**SUNDRY NOTICES AND REPORTS ON WELLS**  
*Do not use this form for proposals to drill or re-enter an abandoned well. Use Form 3160-3 (APD) for such proposals.*

8. Well Name and No. Farrell Federal # 6

9. API Well No. 30-041-10411

## Proposed Plug & Abandonment Procedure

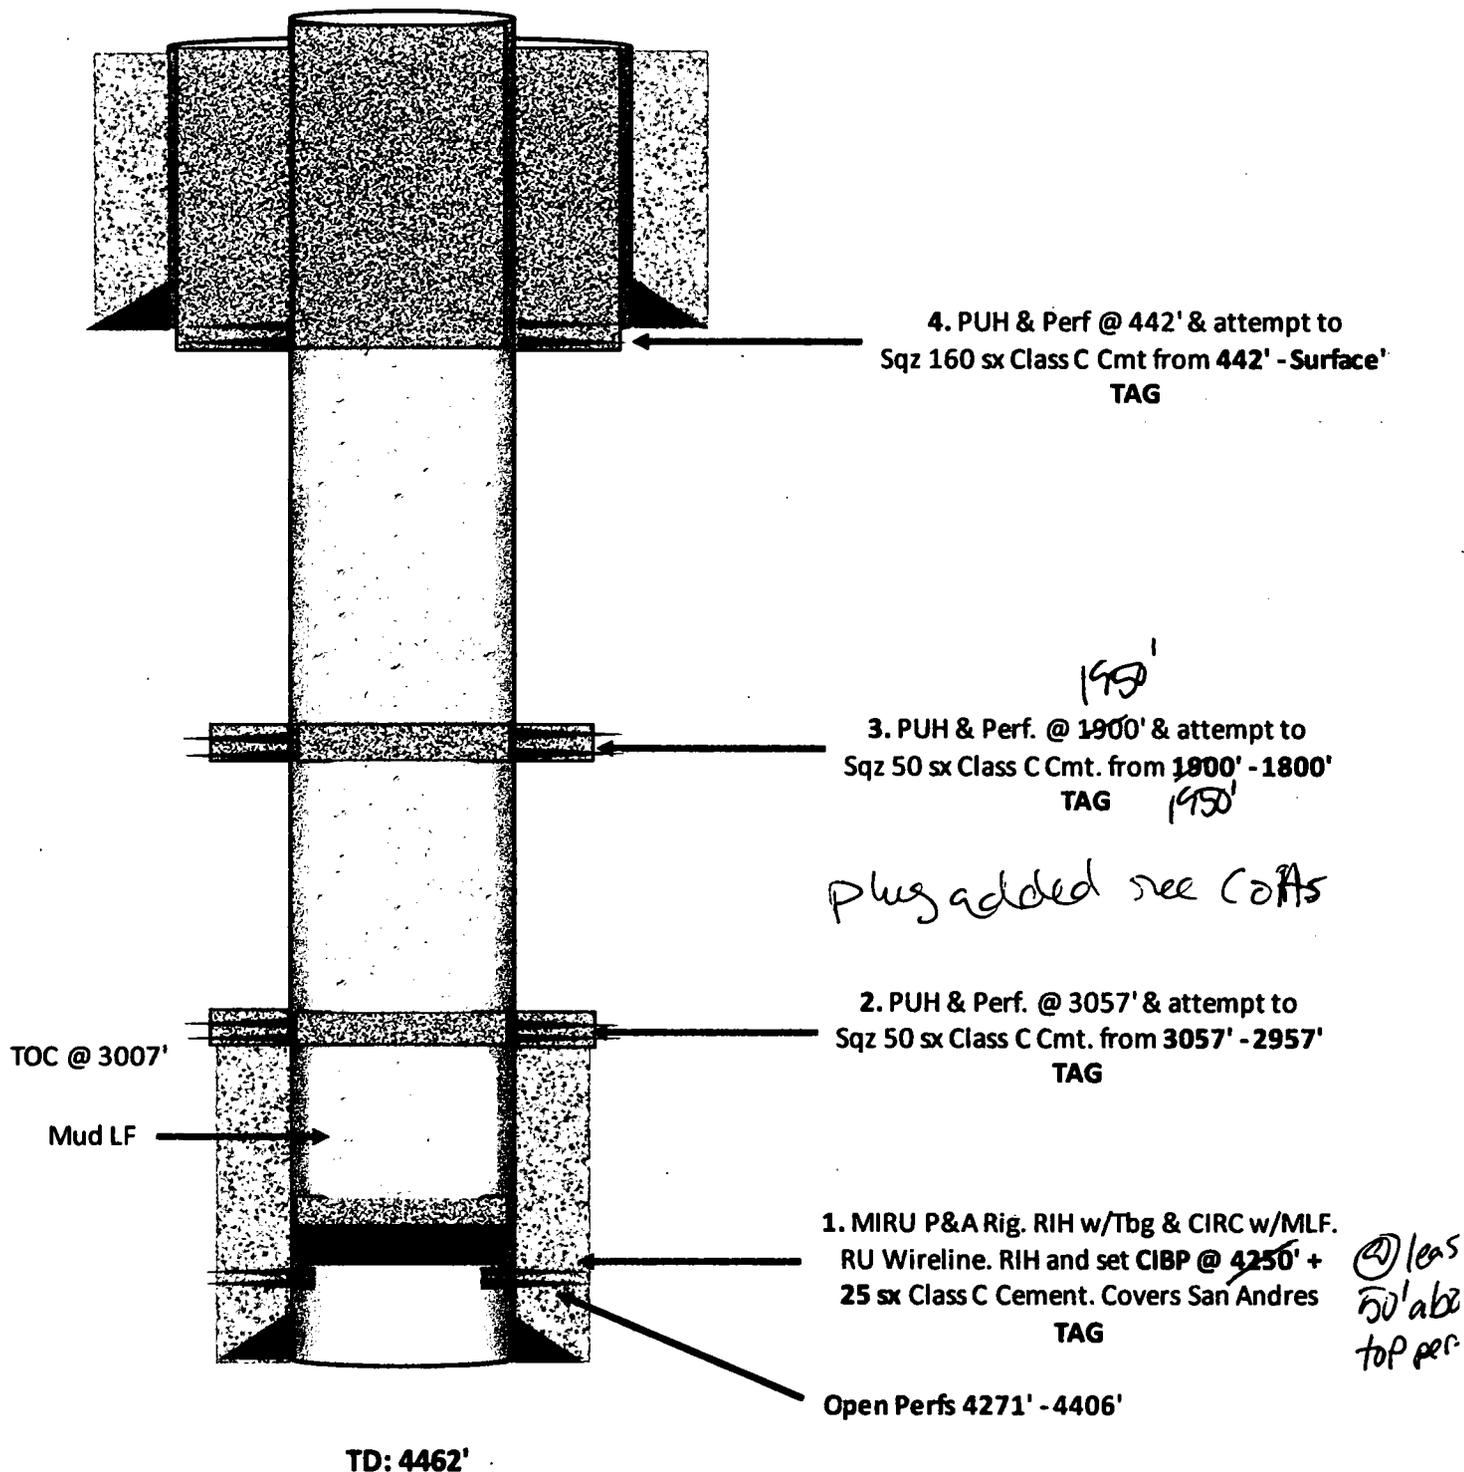
1. Operator shall place CIBP at 4,221' (50'-100' above top most perf) and place 25 sx of Class C cement on top as proposed. WOC and TAG.
2. Operator shall perf and squeeze at 3,057' as proposed. Operator shall place a balanced Class C cement plug from 3,057'-2,957' as proposed. WOC and TAG.
3. Operator shall perf and squeeze at 2,350'. Operator shall place a balanced Class C cement plug from 2,350'-2,225' to seal the Yates Formation and the bottom of the Salt. WOC and TAG.
4. Operator shall perf and squeeze 50 sx of class C cement as proposed at 1,950'. Operator shall place a balanced Class C cement plug from 1,950'-1,800' to seal the top of the Salt. WOC and TAG as proposed.
5. Operator shall perf and squeeze at 442' as proposed. Operator shall place a balanced Class C cement plug from 442' to surface to seal the 8-5/8" casing shoe.
6. See Attached for general plugging stipulations.
